August 2, 2017

Re: Interim Action Work Plan and Response to Ecology Comments
Claremont Village Shopping Center
4821 and 4925 Evergreen Way
Everett, Washington
VCP Number NW2961

Interim Action Work Plan, Claremont Village Shopping Center, Everett, Washington

Figure 2:

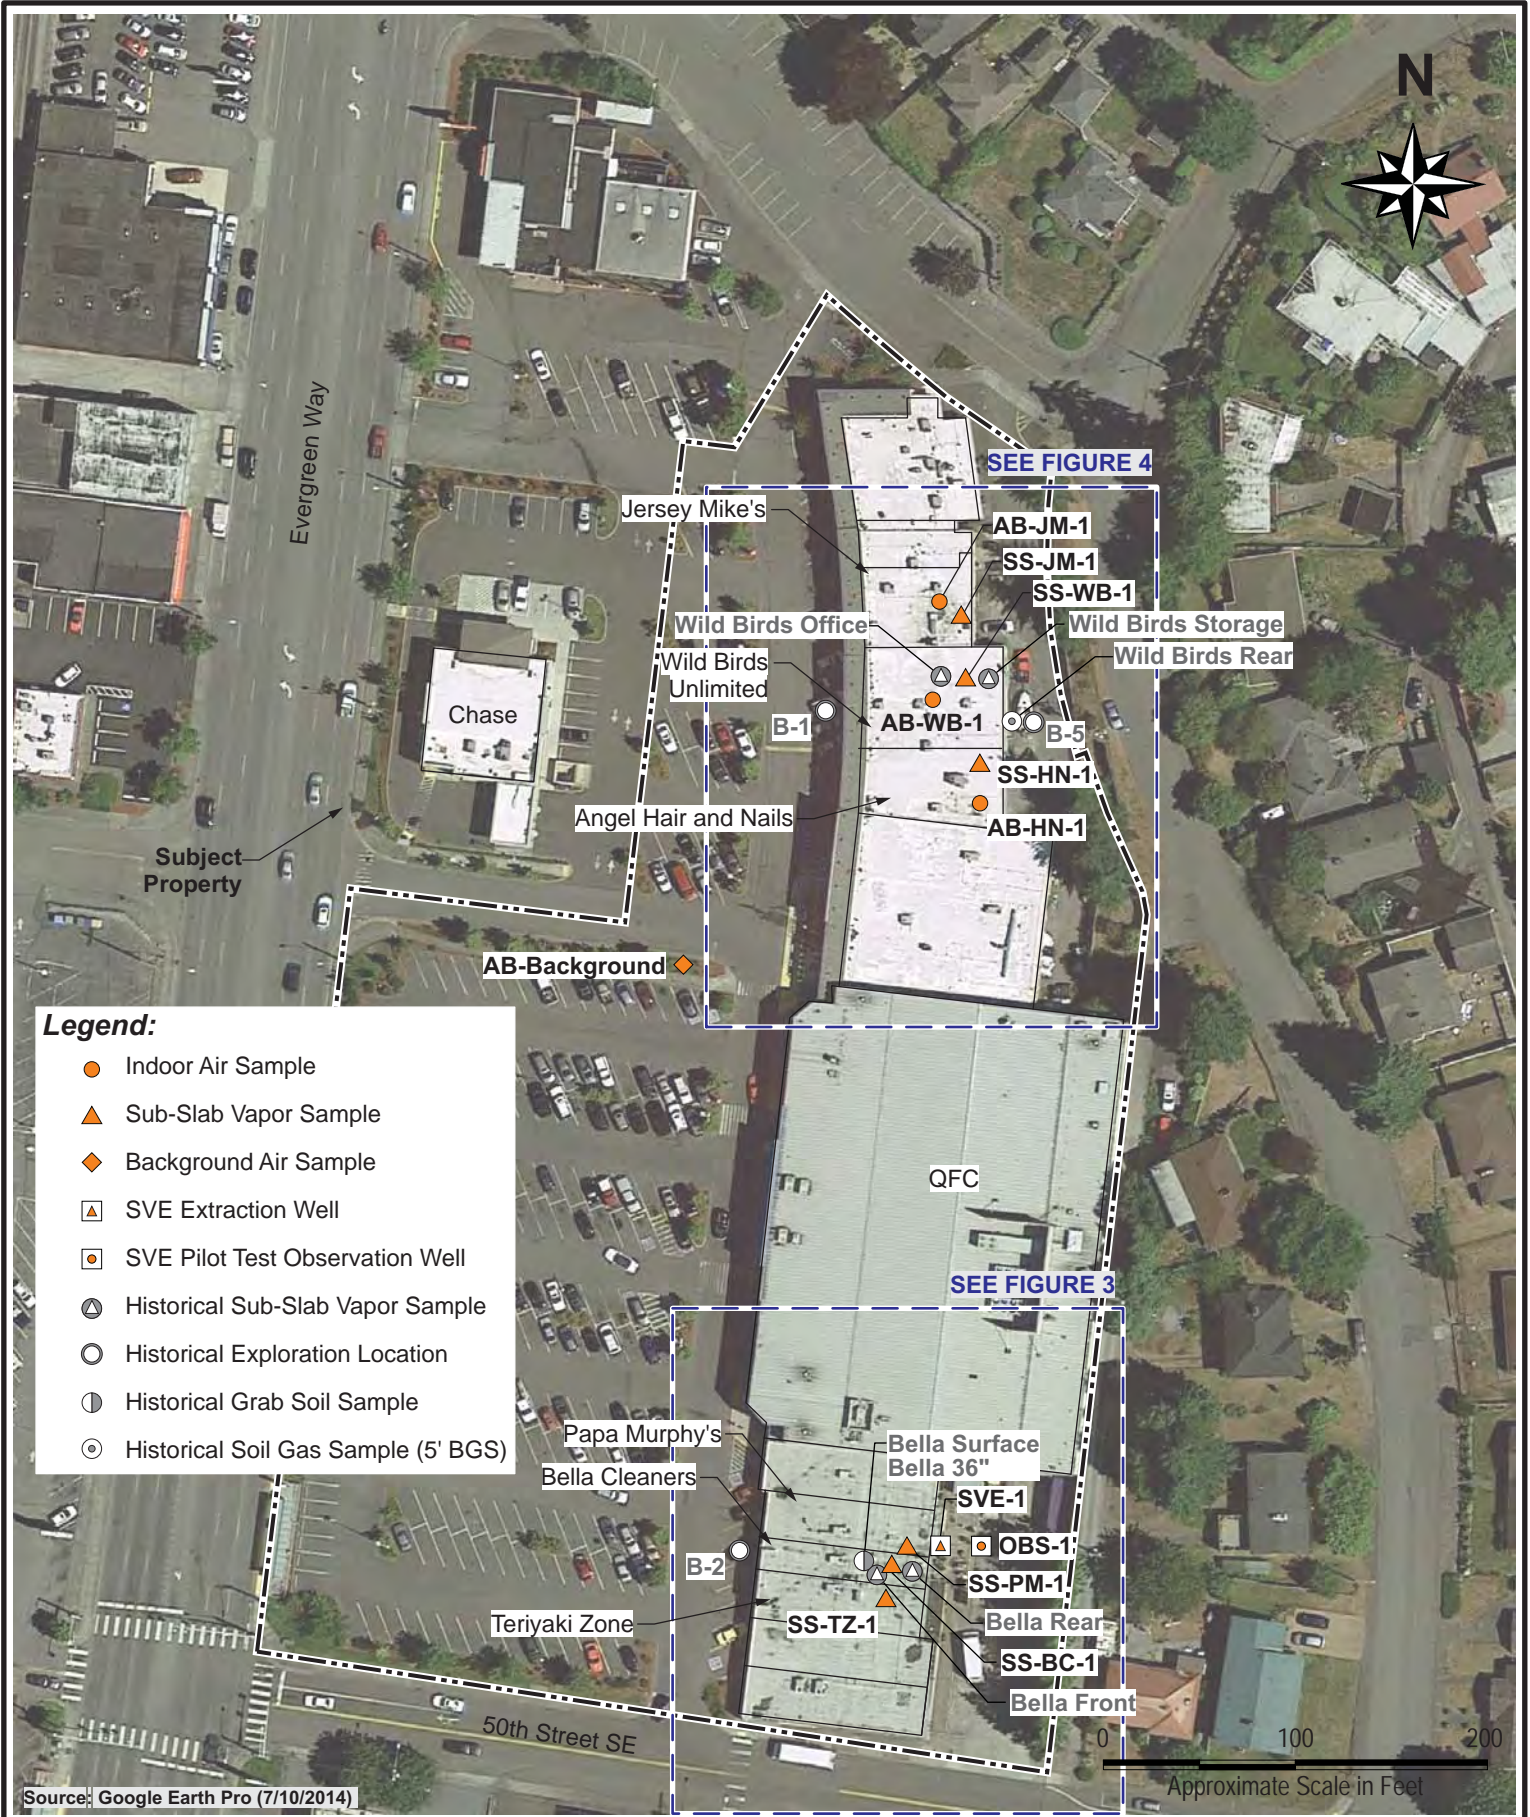
Ecology Comment 2: *Groundwater at the Site has not been adequately characterized. The groundwater flow direction has not been determined, therefore it is not known if the grab groundwater samples collected from the soil borings are downgradient of a potential Site source. Additional groundwater characterization is needed to determine if Site groundwater has been impacted.*

- **Response:** Previous grab groundwater sampling at the Site, including to the east (GW-1, collected at the location of OBS-1 on Figure 2) and west (B-2) of Bella Cleaners, and to the west of Wild Birds Unlimited (B-1) has not shown the presence of dry cleaning related chemicals in groundwater. PCE was detected in one groundwater sample, collected east of the Wild Birds Unlimited facility, but at a concentration significantly below the relevant MTCA screening level for unrestricted use. While we understand Ecology's interest in understanding groundwater flow, the lack of significant detections in previous sampling suggests that groundwater has not been impacted. Therefore, we propose moving forward with addressing soil concerns by implementing SVE as an interim action without conducting additional groundwater

characterization. If Ecology requires further site characterization in the future to evaluate the Site for final closure, we will address those items at that time.
